**RE: Perez Collision Center Addition
2415 2nd Street NW
Grading and Drainage Plan
Engineer's Stamp Date: 04/25/18
Hydrology File: H14D039**

Based upon the information provided in your resubmittal received 05/04/18, the Grading and Drainage Plan **is not** approved for Building Permit and SO-19 Permit. The following comments need to be addressed for approval of the above referenced project:

CONCEPTUAL LAYOUT

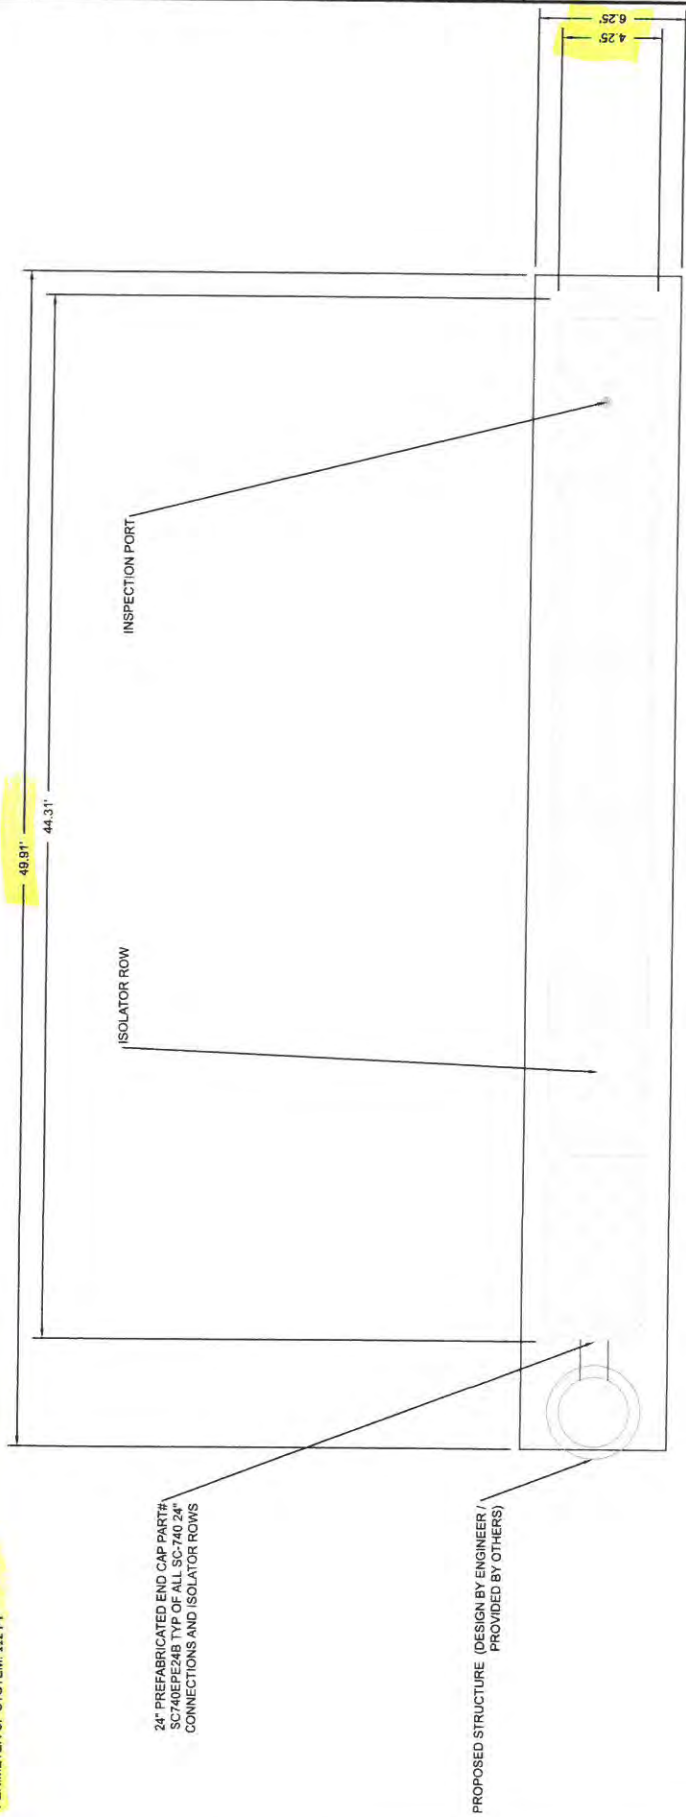
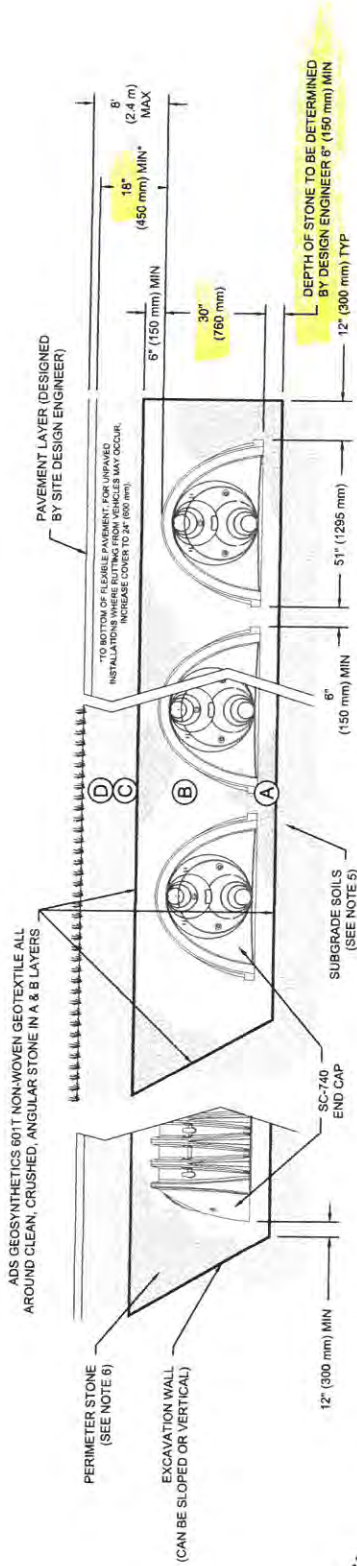
1. Please show each first flush pond volume.
2. Please provide the weir calculations for the curb cuts.
3. Please provide the inlet capacity calculations for the Type "D" inlets.
4. Please provide the invert elevations on both ends of the 4" PVC.
5. Please provide the flow calculations of the 4" PVC.
6. Please provide the drainage calculations for detention. If this is only a first flush pond then label it as first flush pond instead of detention.
7. Please provide the drainage calculations for the retention pond (ADS Chamber) 100 year – 10 day.
